**SAFETY EVALUATION
FOR THE
GENERAL ELECTRIC TOPICAL REPORT
QUALIFICATION OF THE ONE-DIMENSIONAL
CORE TRANSIENT MODEL FOR
BOILING WATER REACTORS
NEDO-24154 and NEDE-24154-P
Volumes I, II and III**

**Prepared By
Reactor Systems Branch, OSI**

June 1980

Figure 1 Axial Power Profile Turbine Trip 1

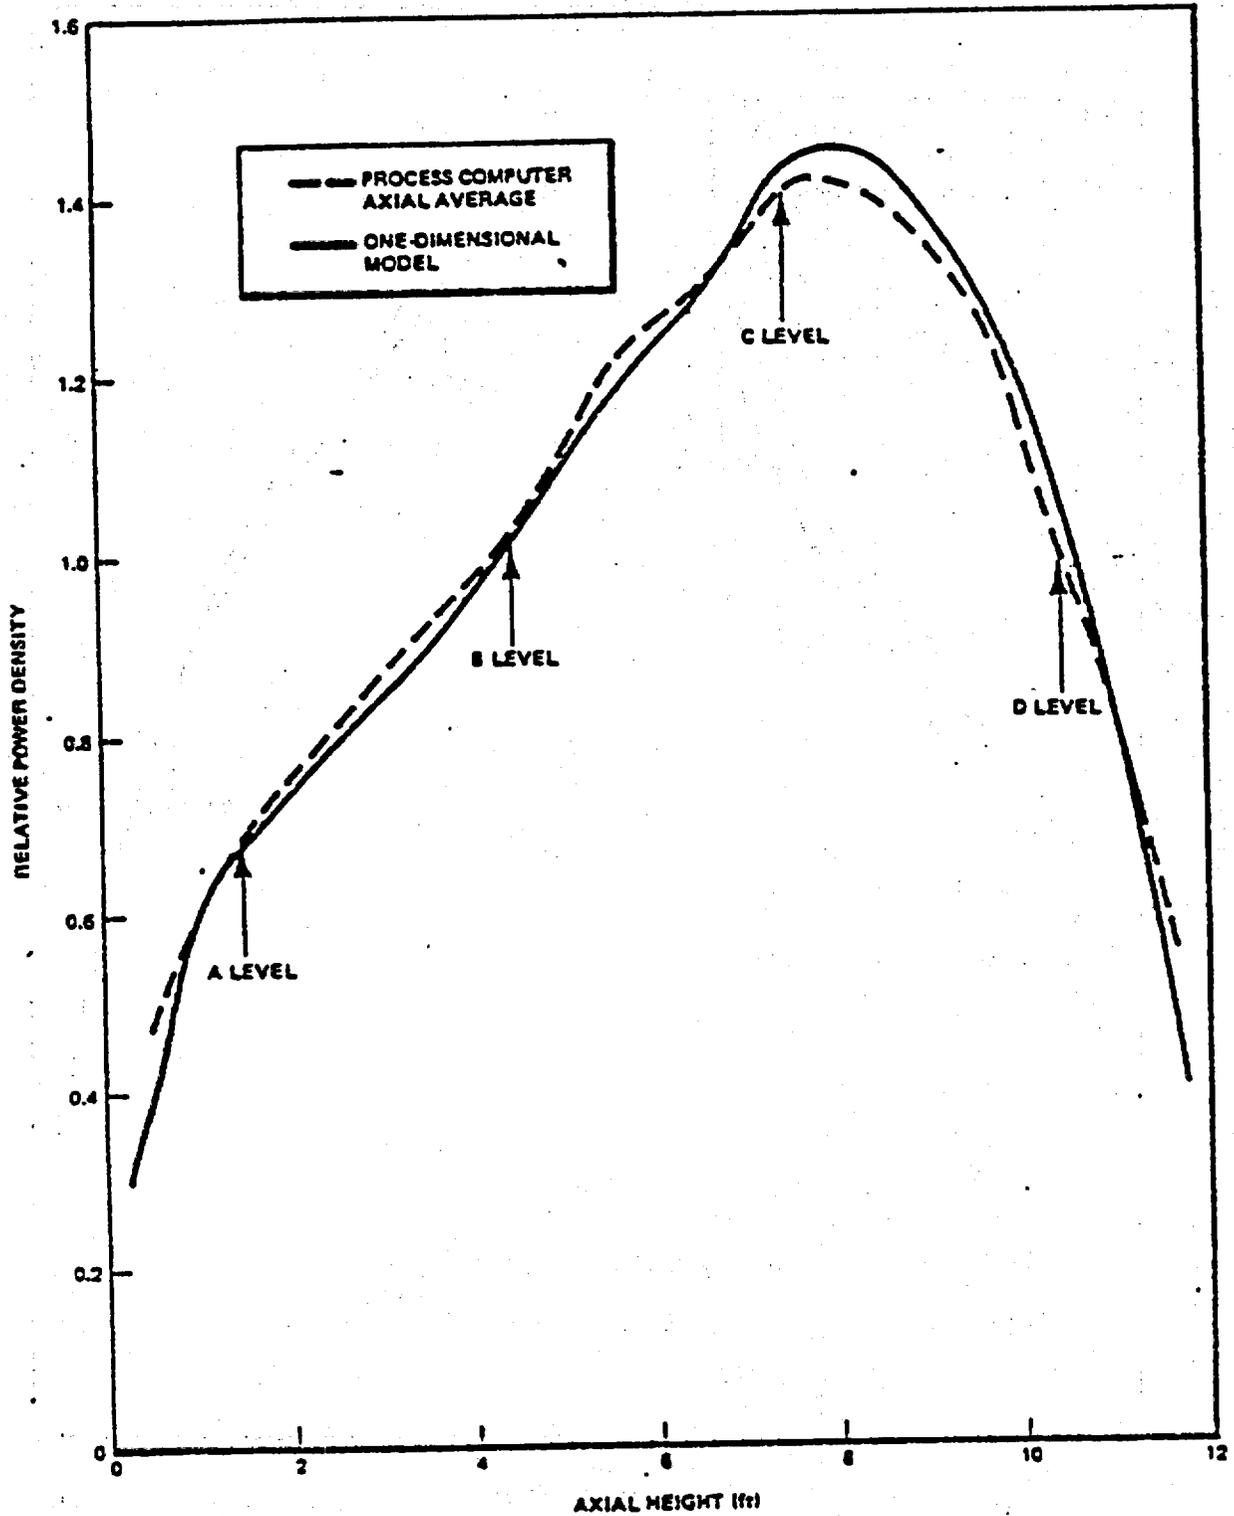
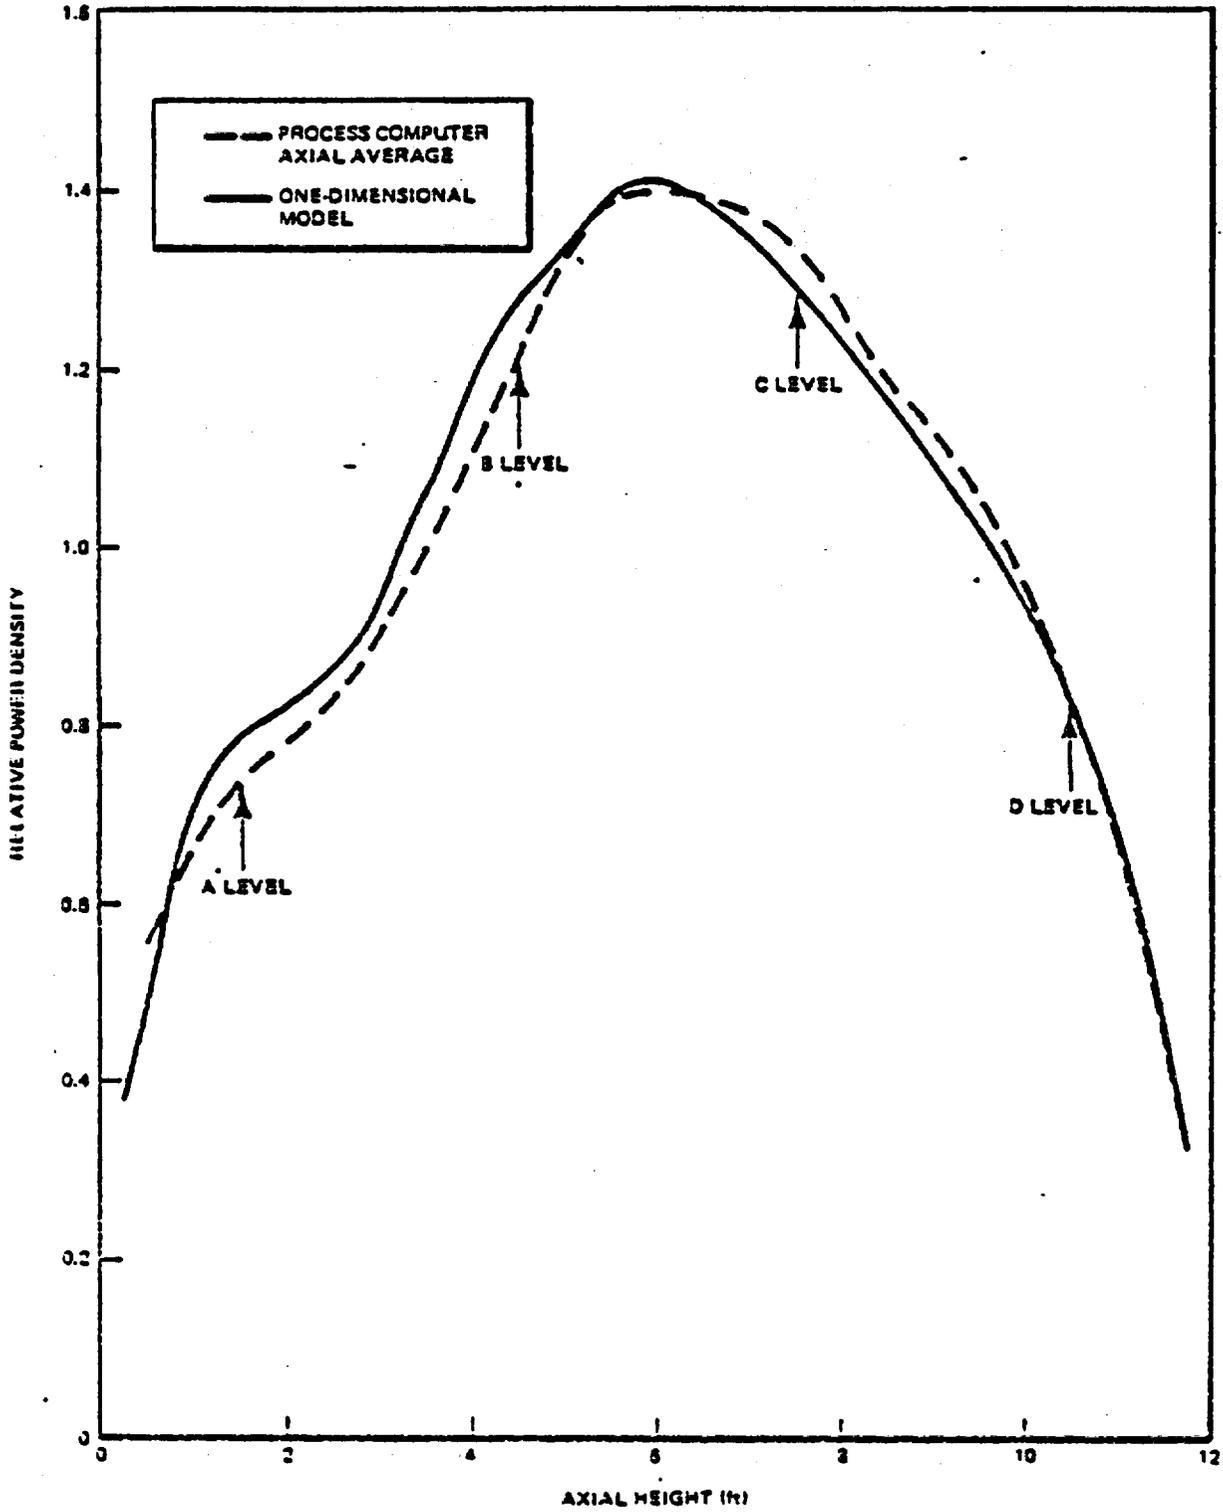
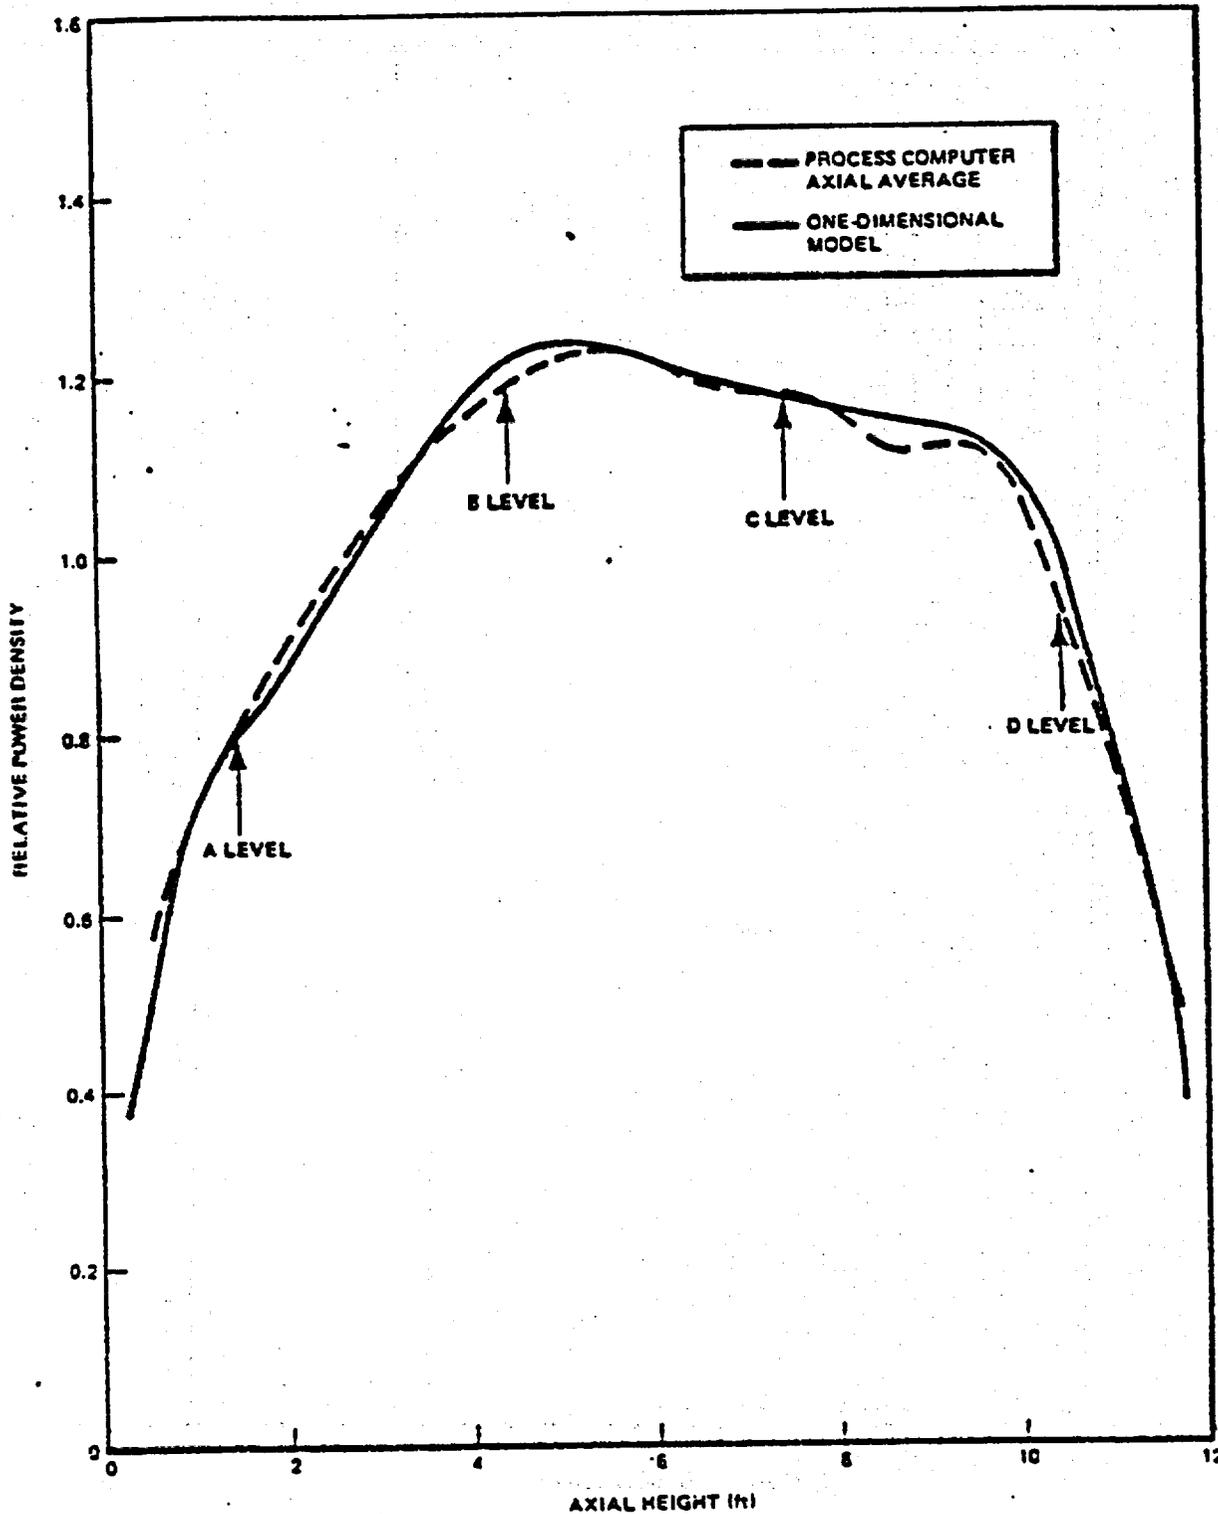
Figures 1 through 3 (reproduced from NEDO-24154) present comparisons of axial neutron flux variations as measured (calculated by the process computer) and calculated by the ODYN code before the initiation of the tests. Figures 4 through 6 present comparisons of prompt neutron power as measured and calculated by the ODYN code during the tests.

Figure 8 KKM Turbine Trip Prompt Neutron Power

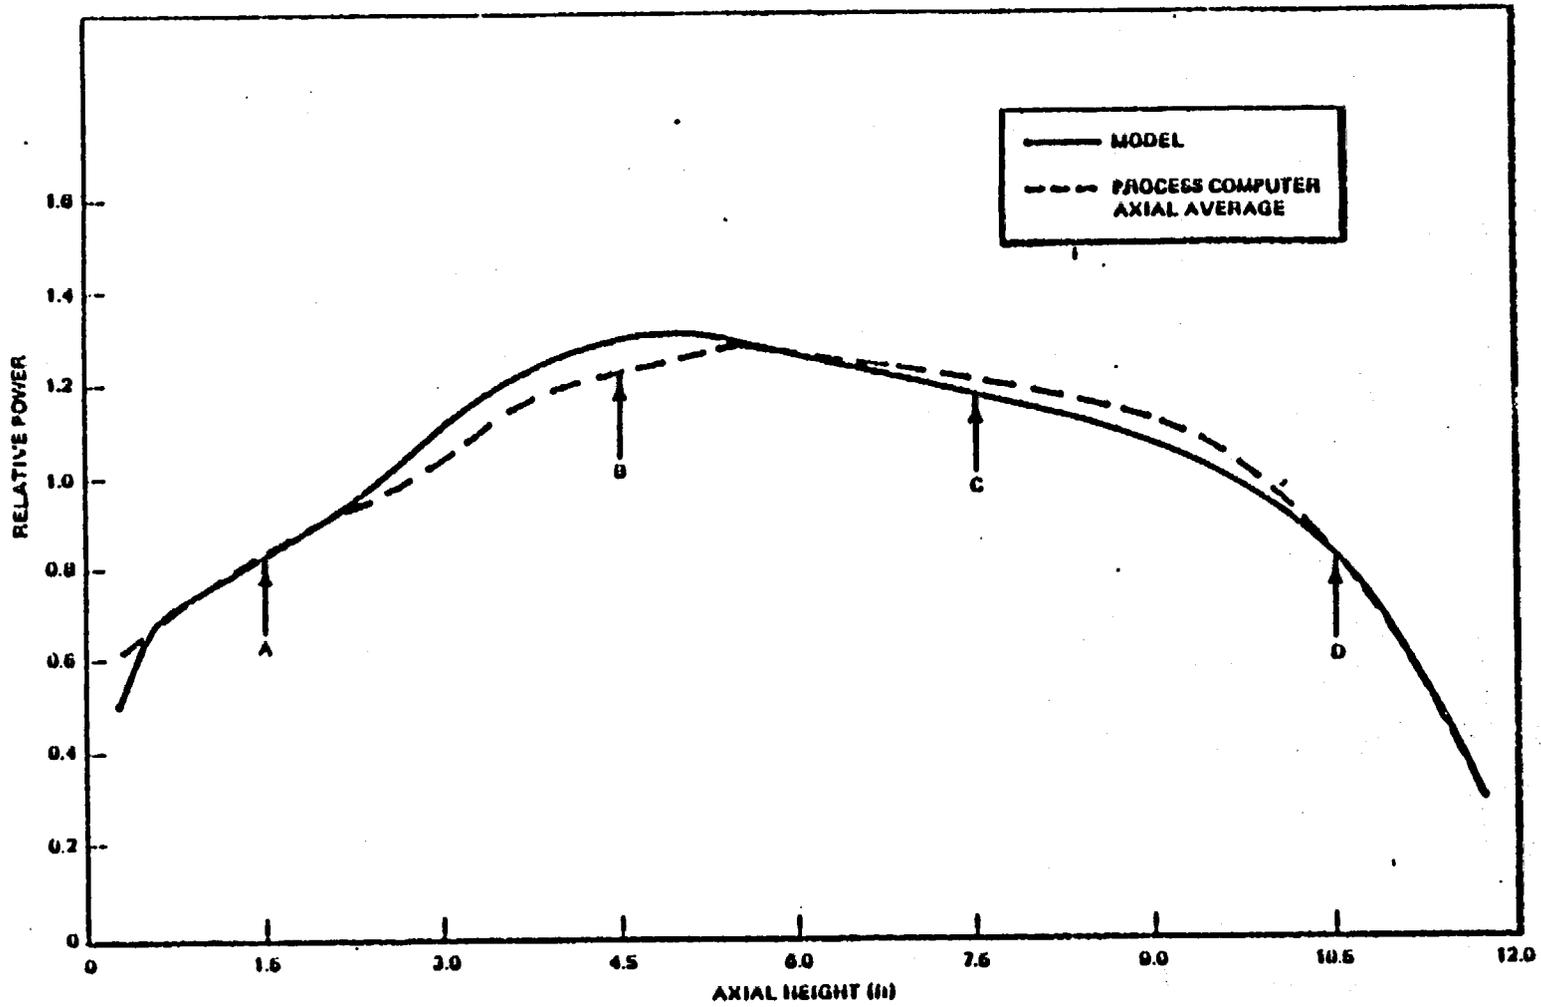
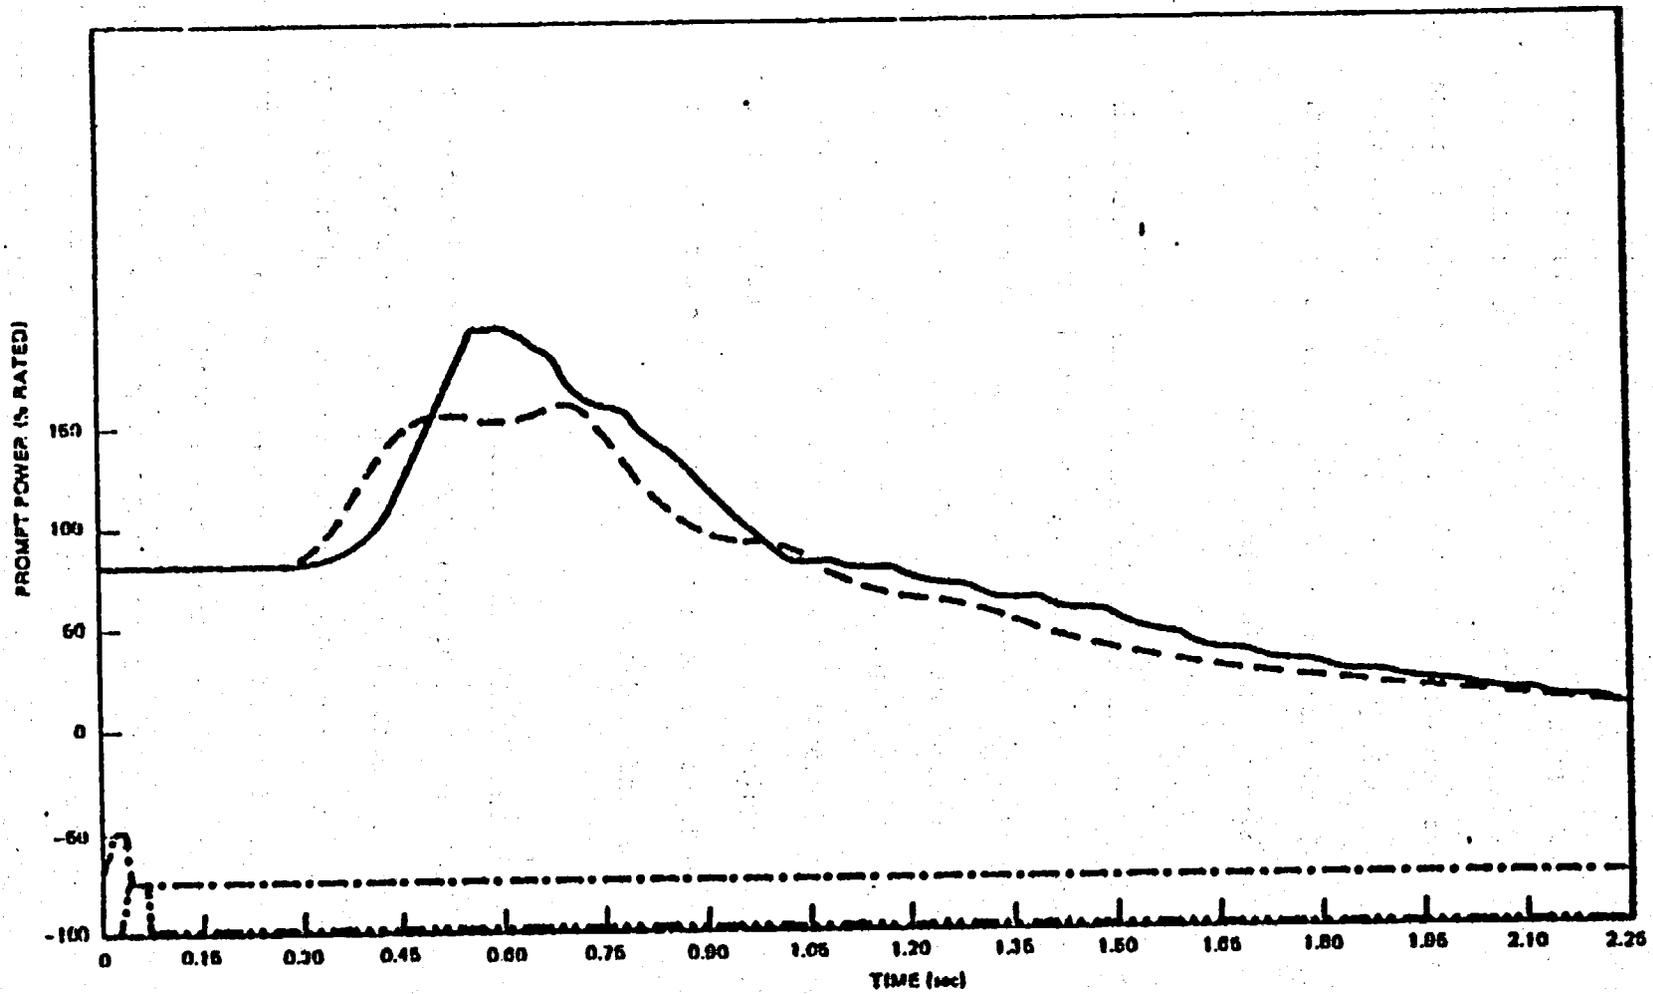
The measurement of neutron flux indicates a double peak behavior. This double peak was attributed to an oscillation in core pressure which was thought to be enhanced by KKM bypass characteristics. The ODYN code overpredicted the initial neutron flux peak by approximately 53% and underpredicted the second peak. We estimated that the integral of the calculated nuclear power was higher by approximately 20% than the data. Figures 7 and 8 present the comparisons of measured and calculated axial neutron and prompt neutron fluxes respectively.

Figure 15
11-71

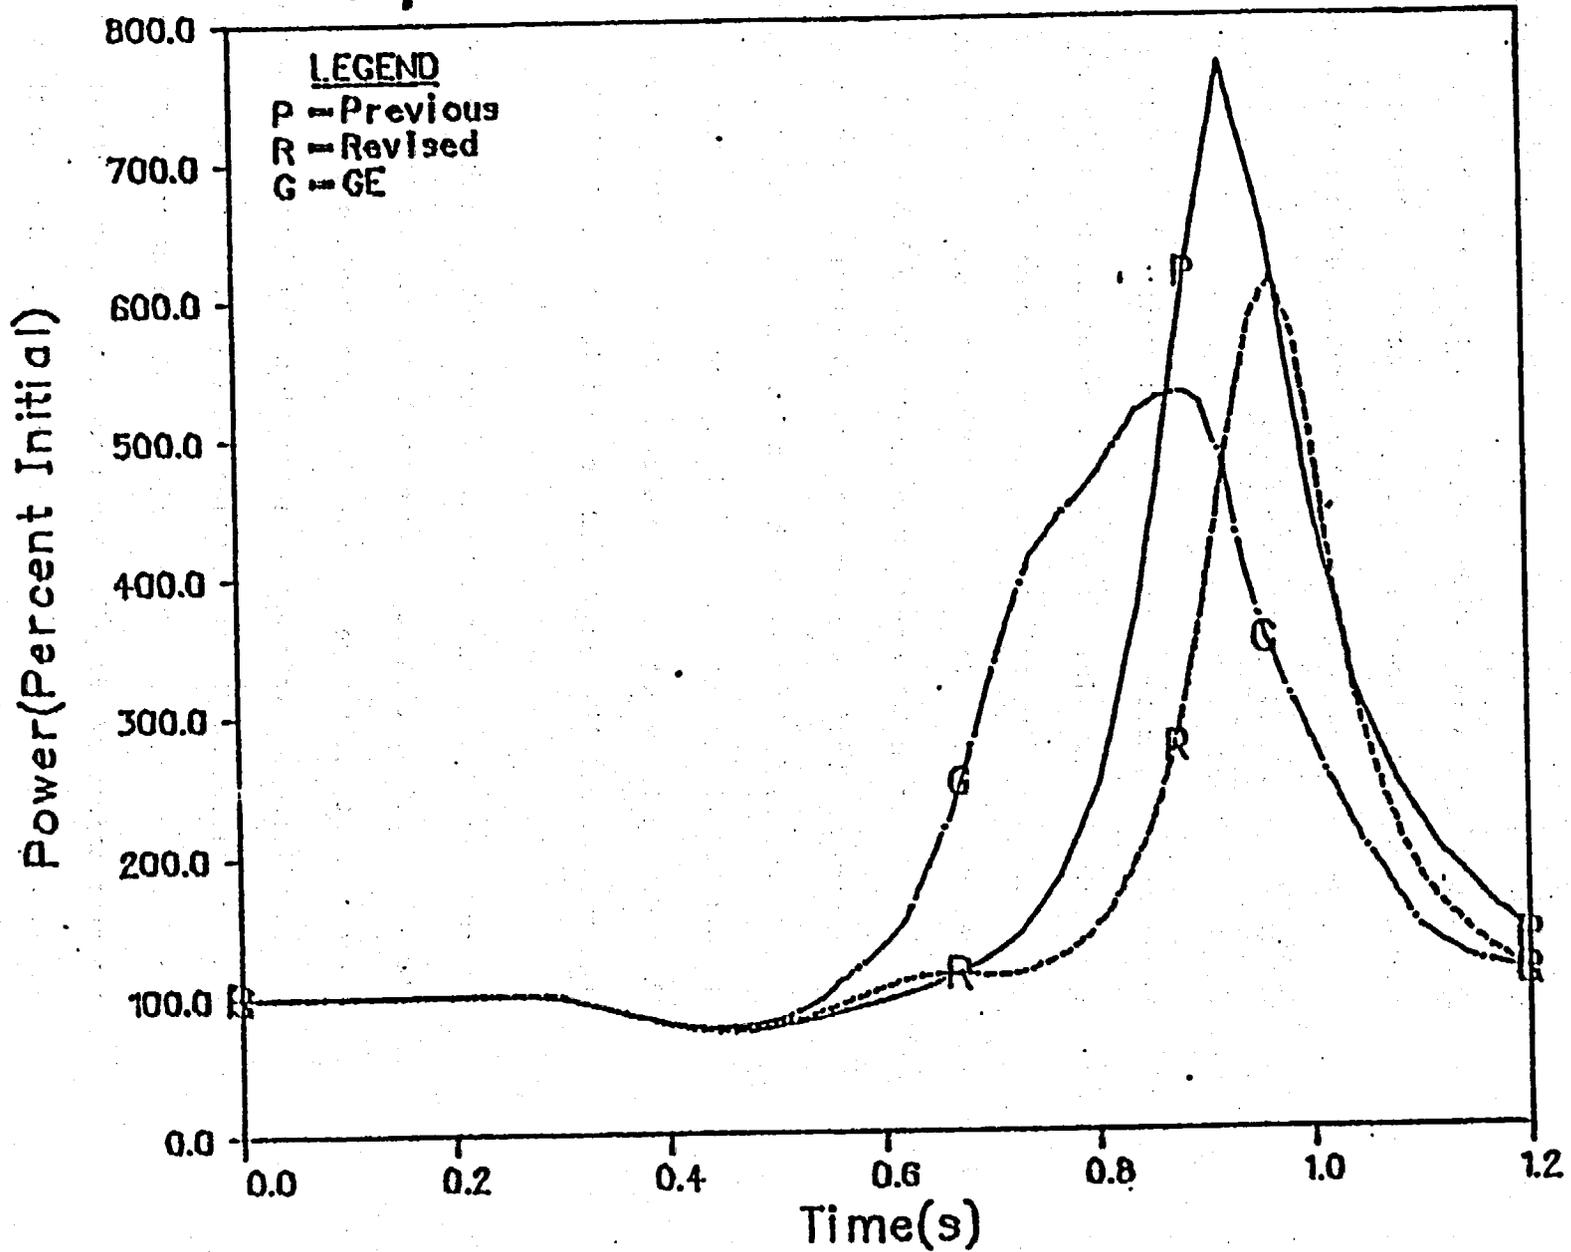
Some sensitivity studies were also performed. Some of the differences noted in the meeting did not change the BNL results substantially. However the difference in the separator inventories and the required renodalization around the separators to accommodate proper inventories inside and outside of the separators and inclusion of a separate flow path between the steam dome and outside of the separators (bulkwater), reduced the neutron power and the total energy output in the licensing basis transient (TTWOB). The total energy output, the integral of the neutron power, predicted by BNL during the transient was less than that in the second calculation performed by General Electric. However, the General Electric calculation still indicated an earlier rise and an earlier fall-off of the total core power than the BNL calculation. Figure 15 presents these two BNL calculations as well as the General Electric calculation.

The primary reason for the change in the energy outputs as well as disagreement in the shape of the neutron power transient was the new inlet core flow calculation by the BNL. The core inlet flow in the second BNL calculation was in closer agreement with the second GE calculation in that it exhibited similar oscillatory behavior.
